Class 1 Permit Modification Notifications

**Waste Isolation Pilot Plant
Carlsbad, New Mexico**

WIPP HWFP #NM4890139088-TSDF

July, 2008

Figure N-1
Panel Flow Area

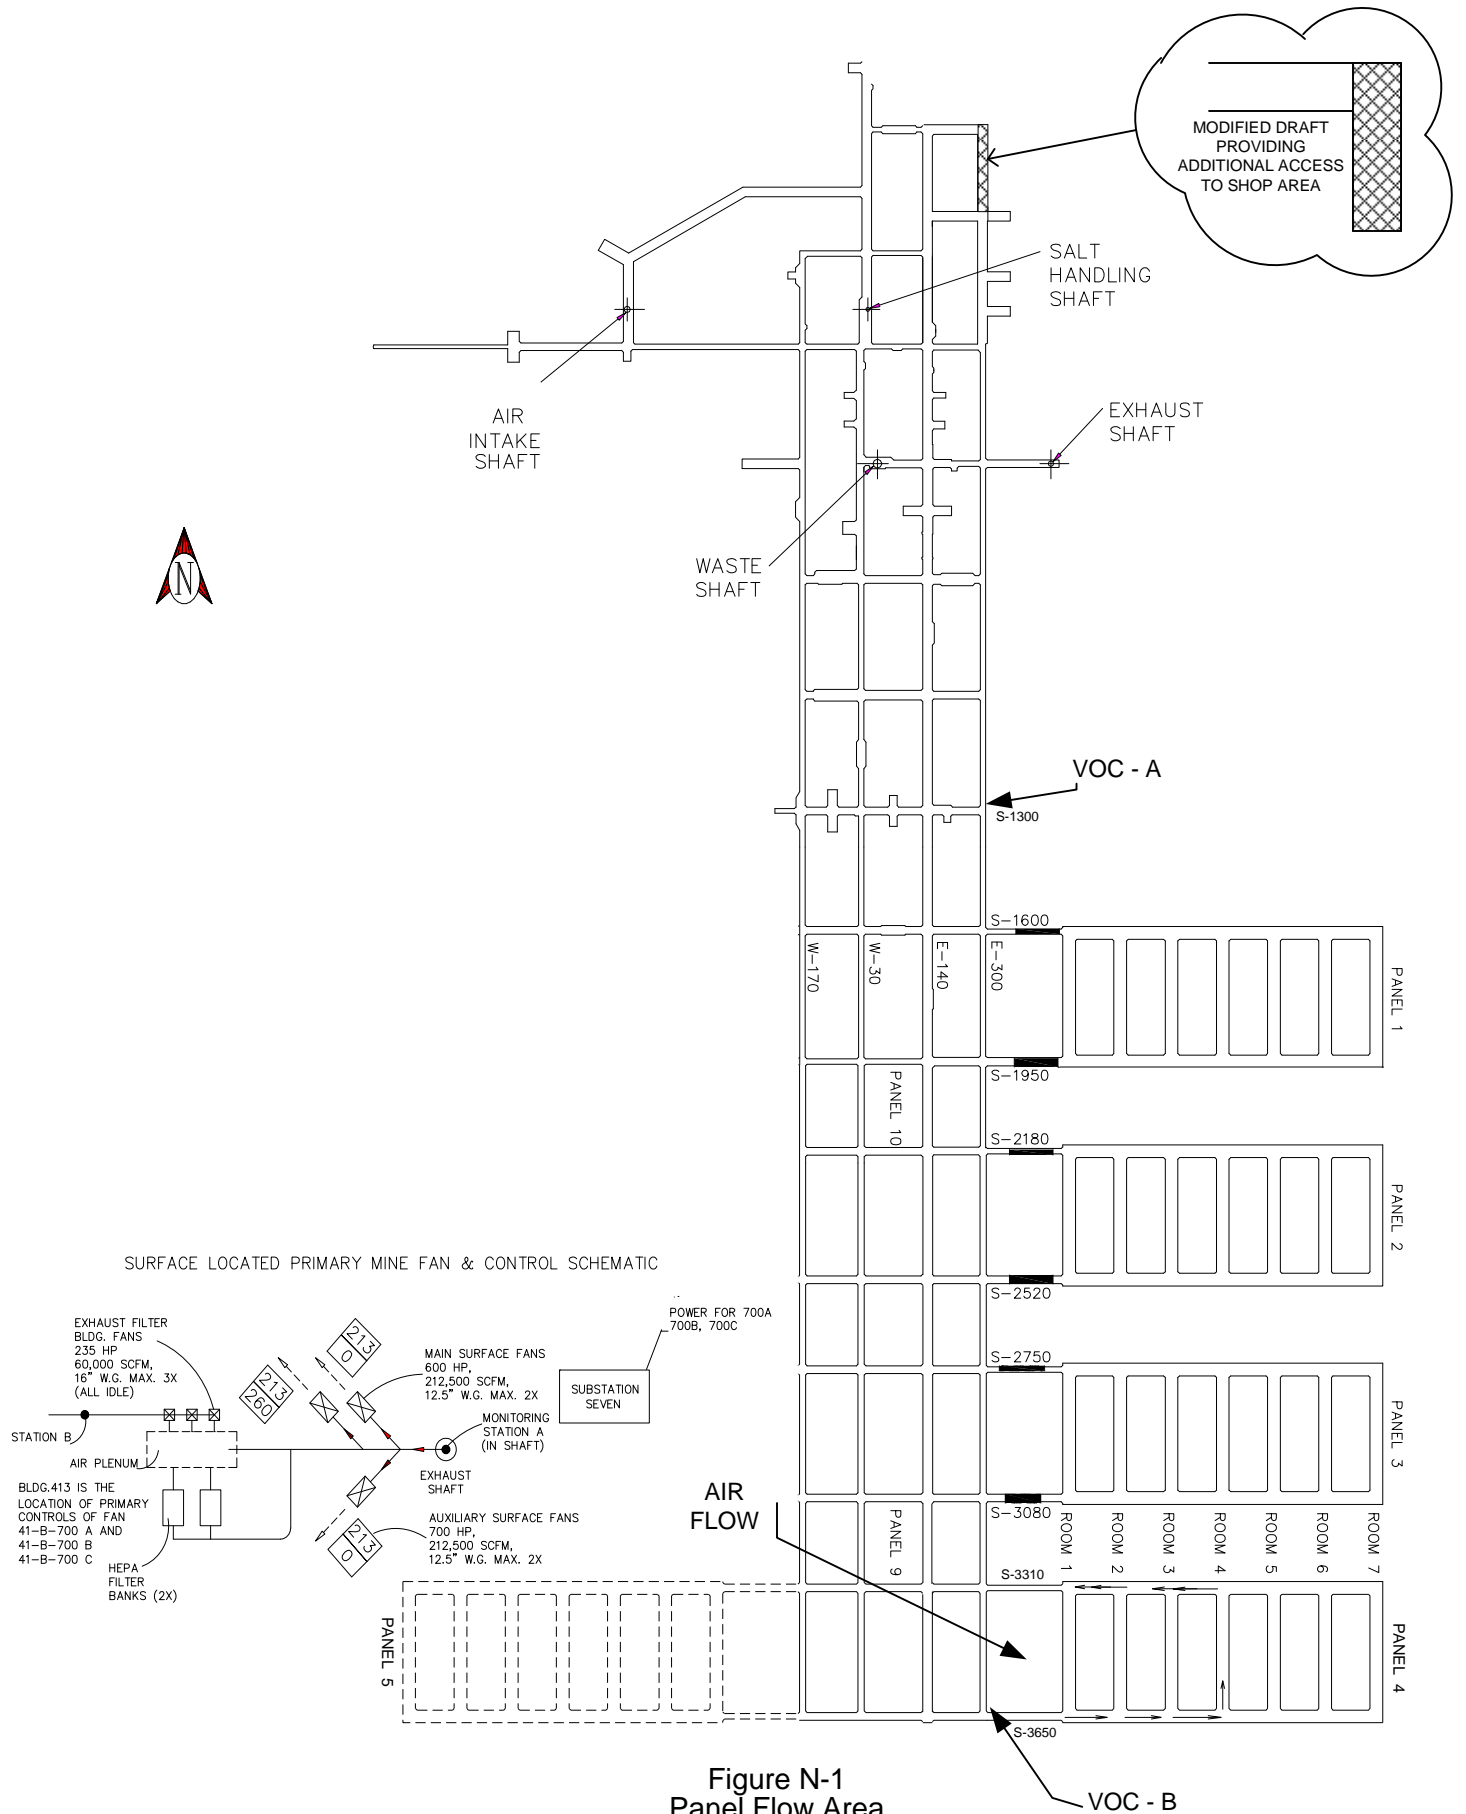
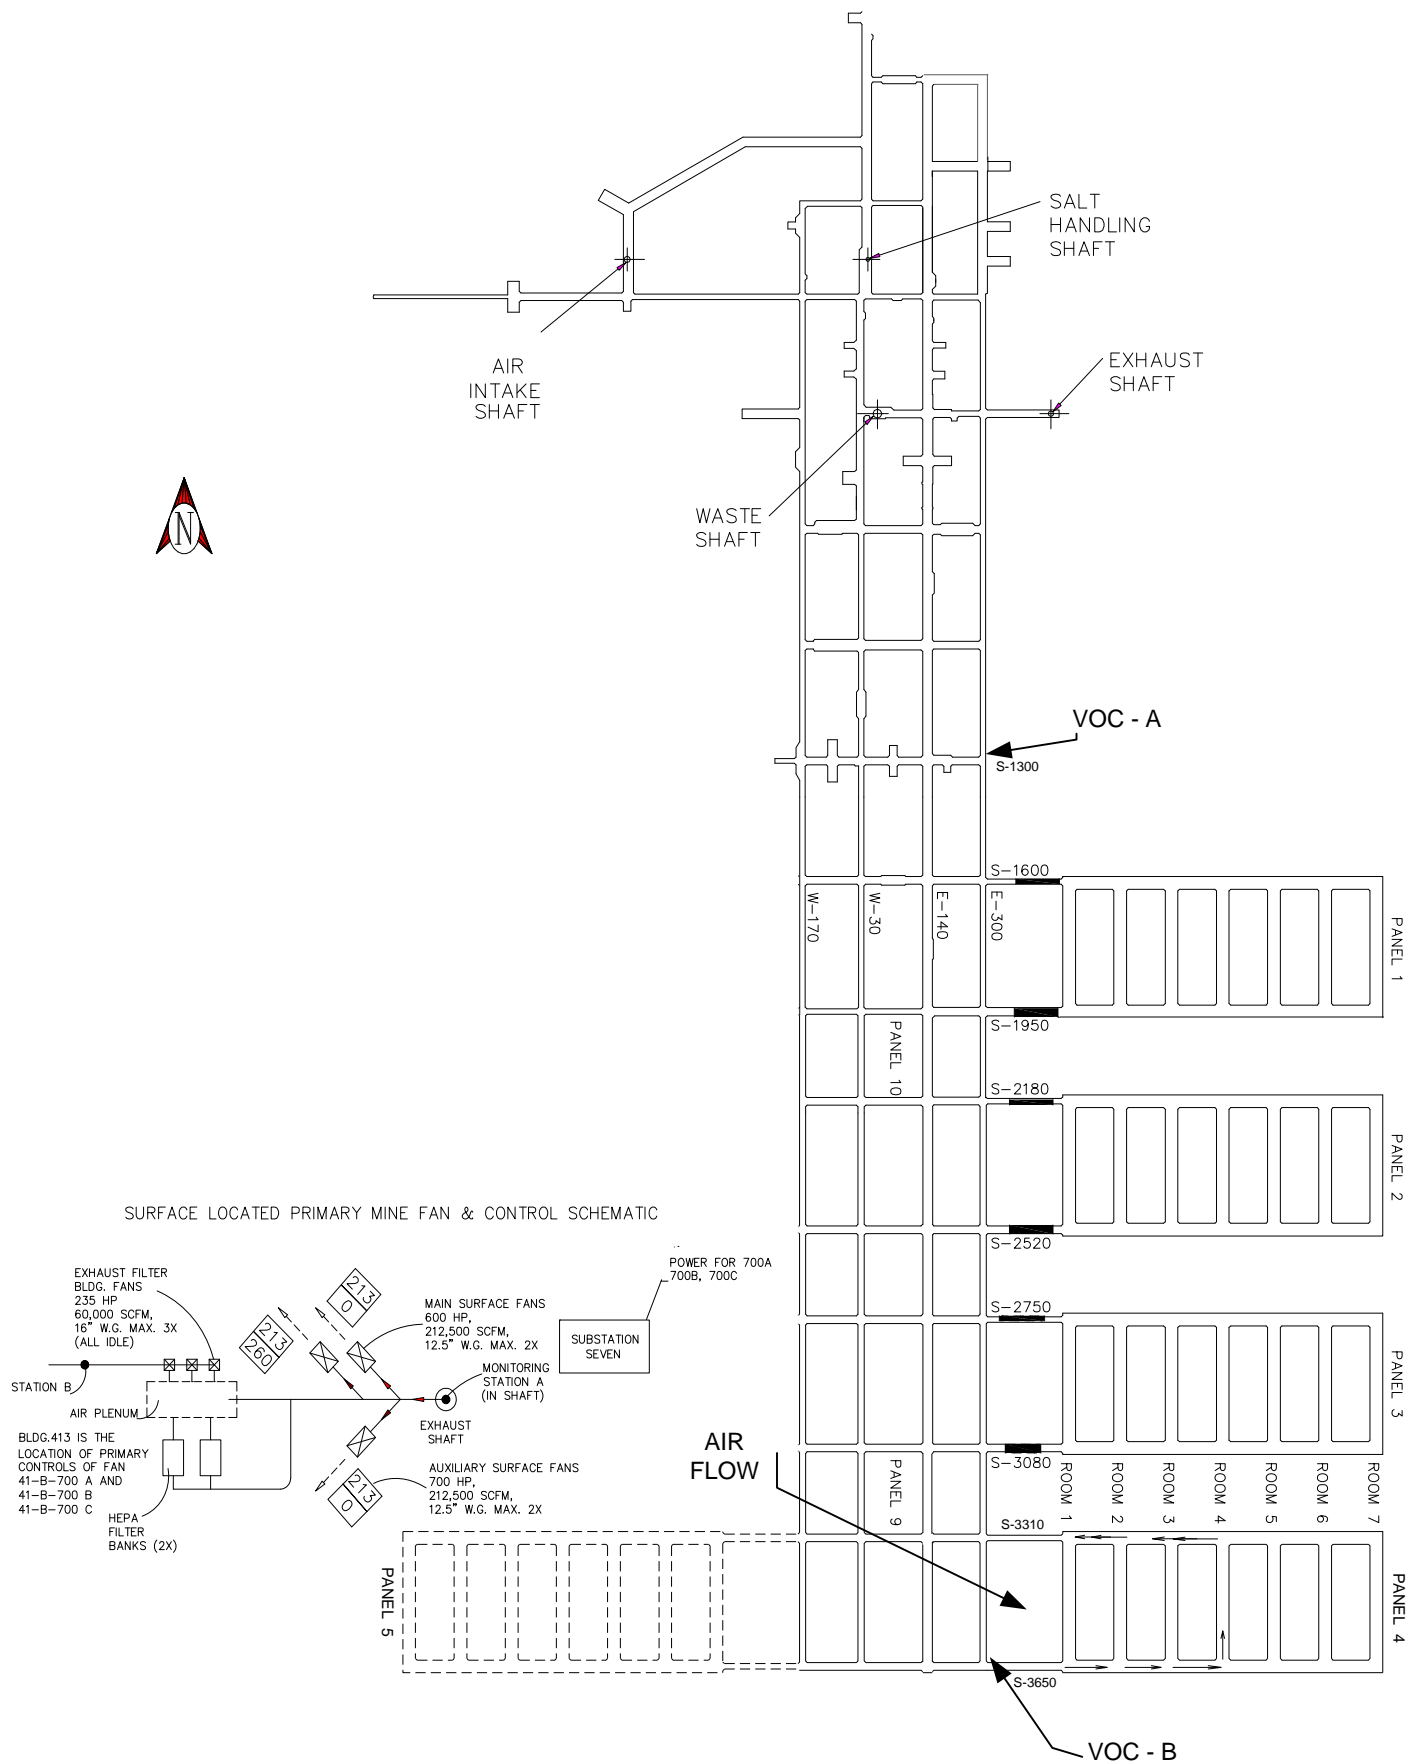
Discussion: Various figures in the HWFP of the WIPP underground area are being revised to reflect a new area mined for underground shops. These include Figures F-3, F-5, I-6, M2-1, M2-2, N-1, O3-1 and O3-2. Figure F-3 has been annotated with a "cloud" showing where the change was made. This figure is for informational purposes only. Included in Attachment B of this notification are "clean" figures with the change incorporated.

Revised Figures F-3, F-5, I-6, M1-1a, M2-1, M2-2, N-1, O3-1 and O3-2 are included in Attachment B.
